REGULAR OPEN MEETING OF THE UNITED LAGUNA WOODS MUTUAL ARCHITECTURAL CONTROL AND STANDARDS COMMITTEE*

**Thursday, July 18, 2024 – 9:30 a.m.
Laguna Woods Village Board Room /Virtual Meeting
24351 El Toro Road, Laguna Woods, CA 92637**

DATE: July 18, 2024
FOR: Architectural Control and Standards Committee
SUBJECT: Revision to Standard 18: Gutters and Downspouts

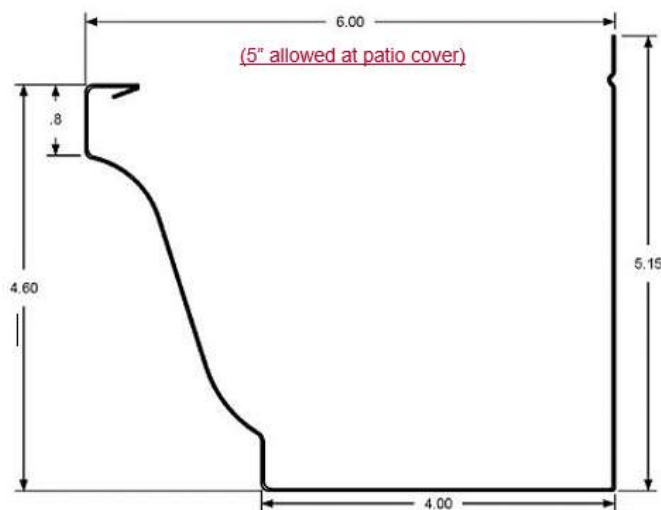
3.3 Downspouts shall be installed at intervals appropriate for its installation in compliance with The Sheet Metal and Air Conditioning Contractors' National Association (SMACNA). ~~No downspout may be installed that will drain into an area that will affect surface drainage in an adverse way.~~

A. In no case shall downspout spacing exceed 40 lineal feet.

B. No downspout may be installed that will drain into an area that will effect surface drainage in an adverse way.
